REV.
A

AS3566

(R) NUT, SELF-LOCKING, CASTELLATED, PREVAILING TORQUE, UNS G41300 OR UNS G43400, UNJ 16 PITCH THREAD FORM

FIGURE 1 - NUT

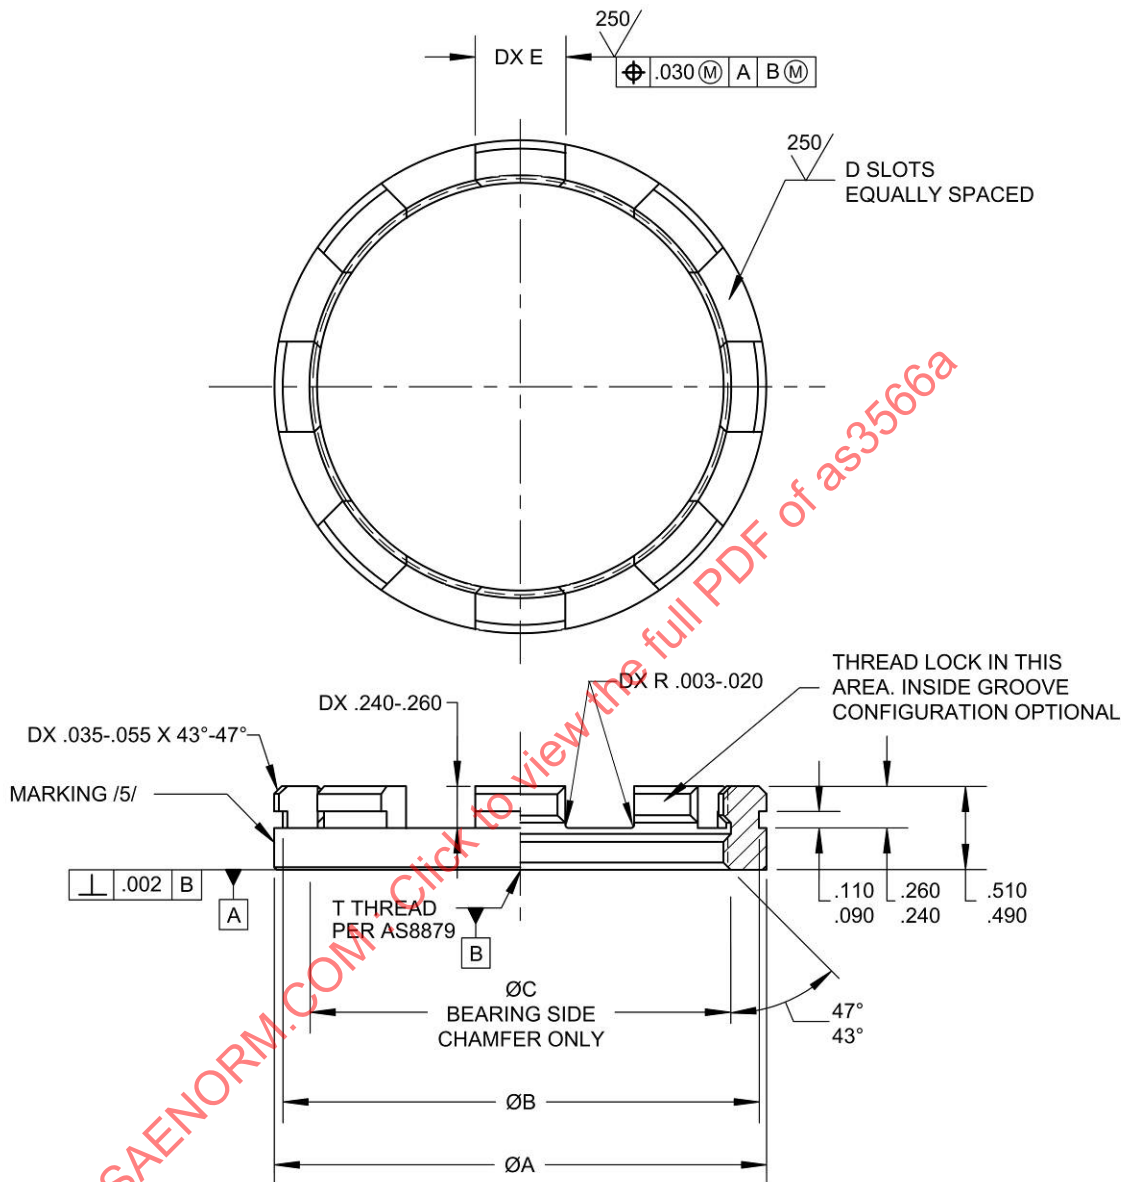
UPDATE THREAD SPECIFICATION TO AS8879, REVISE DATUM CALLOUTS FOR POSITION FCF, ADD INTERNAL CHAMFER AT TOP END, UPDATE REFERENCES AND GENERAL EDITORIAL PRACTICES.
